BLUFFS AT CYPRESS CREEK SUBDIVISION, RESUBDIVISION OF LOTS 13 & 14

APPLICATION NUMBER 2 DATE March 18, 2021

Bluffs at Cypress Creek, Phase One,
APPLICANT Resub of Lots 13 and 14

REQUEST Subdivision

DETAIL SITE PLAN

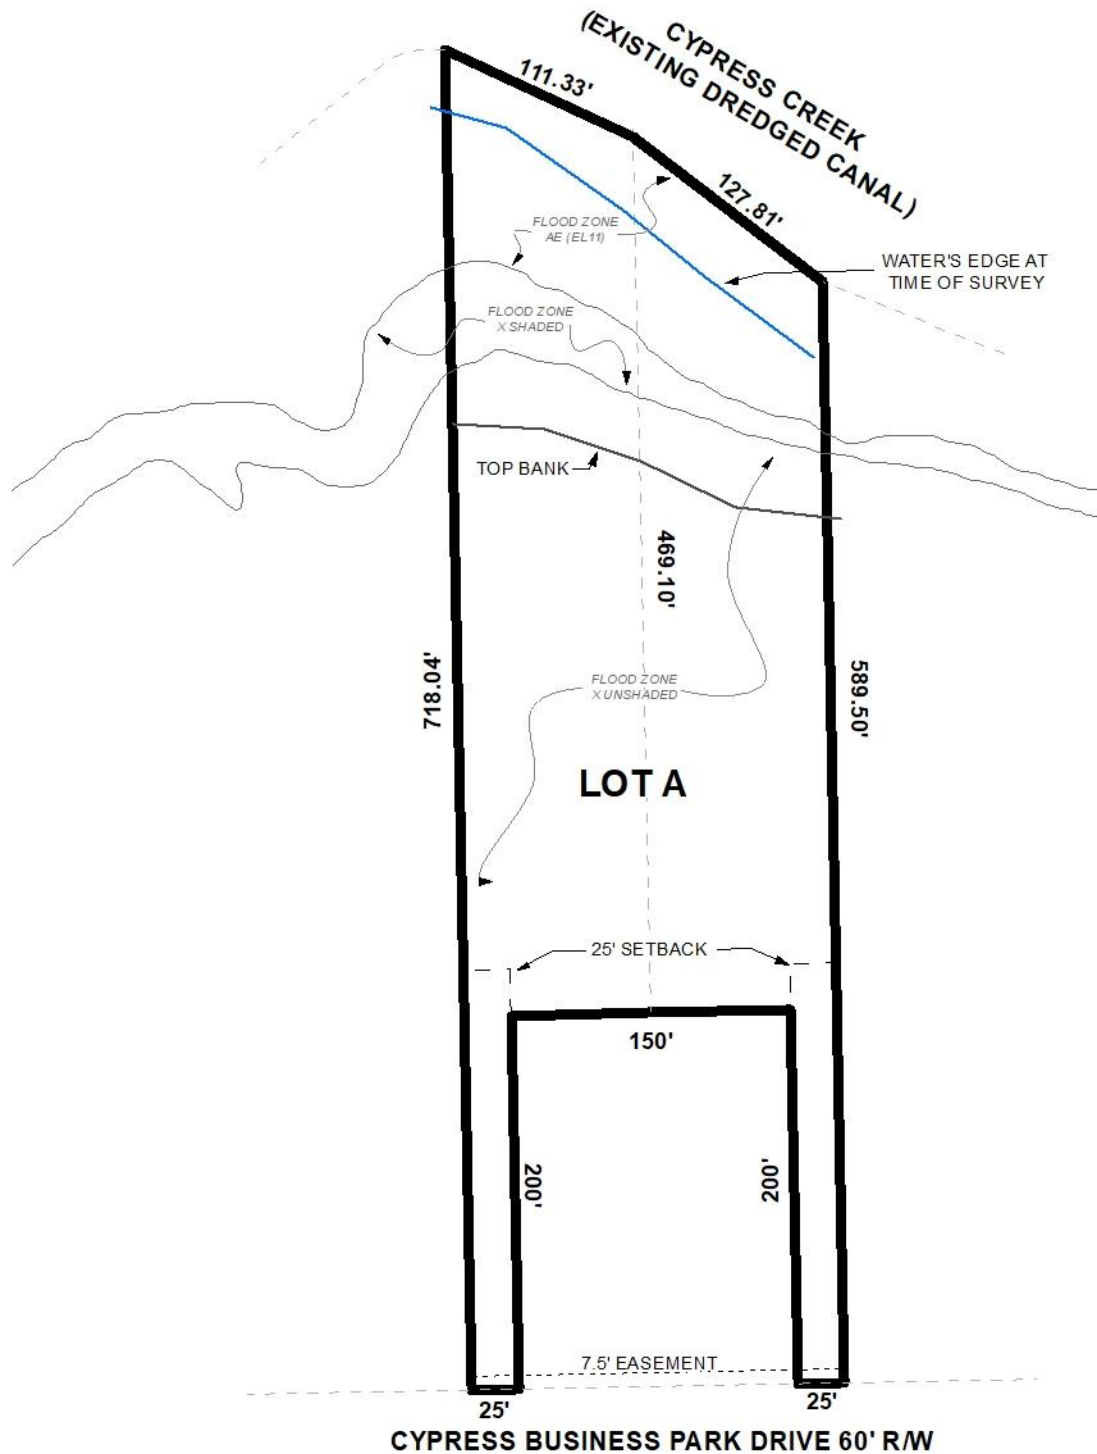
The site has frontage along Cypress Drive (formerly Cypress Business Park Drive), a minor street with a compliant 60-foot right-of-way; therefore, no dedication would be required. The street name should be corrected on the Final Plat as the preliminary plat still labels the street at Cypress Business Park Drive. As on the preliminary plat, the right-of-way width should be retained on the Final Plat. Furthermore, as on the preliminary plat, the 25-foot minimum building setback line should be indicated within the buildable area at the North end of the lot “flag-poles”.

As illustrated on the preliminary plat, the lot size label in both square feet and acres should be retained on the Final Plat, or a table should be furnished on the Final Plat providing the same information. The preliminary plat indicates a drainage and utility easement along the South end of the lot “fingers”. Therefore, a note should be required on the Final Plat stating that no structures shall be constructed or placed within any easement without permission of the easement holder.

A condition of the 2009 approval was *“the placement of a note on the Final Plat stating that Lots...12 & 13, 14 & 15, ... are limited to a shared curb-cut along their common interior lot lines, with the size, design and location to be approved by Traffic Engineering and conform to ASHTO standards”*. As per the Traffic Engineering comments, Lot A is limited to shared curb cuts with Lots 12 and 15 along their common lot lines, with size, location, and design to be approved by Traffic Engineering and conform to AASHTO standards. A note should be required on the Final Plat stating these comments.

- 2) correction of the street name on the Final Plat to Cypress Park Drive;
- 3) retention of the right-of-way width of Cypress Park Drive on the Final Plat;

- 4) retention of the 25-foot minimum building setback line within the buildable area at the North end of the lot “fingers”;
- 5) retention of the lot size label in both square feet and acres on the Final Plat, or the furnishing of a table on the Final Plat providing the same information;

- 6) placement of a note on the Final Plat stating that no structures shall be constructed or placed within any easement without permission of the easement holder;

- 8) *placement of a note on the Final Plat stating the Traffic Engineering comments: (Lot A is limited to shared curb cuts with Lots 12 and 15 along their common lot lines, with size, location, and design to be approved by Traffic Engineering and conform to AASHTO standards.);*
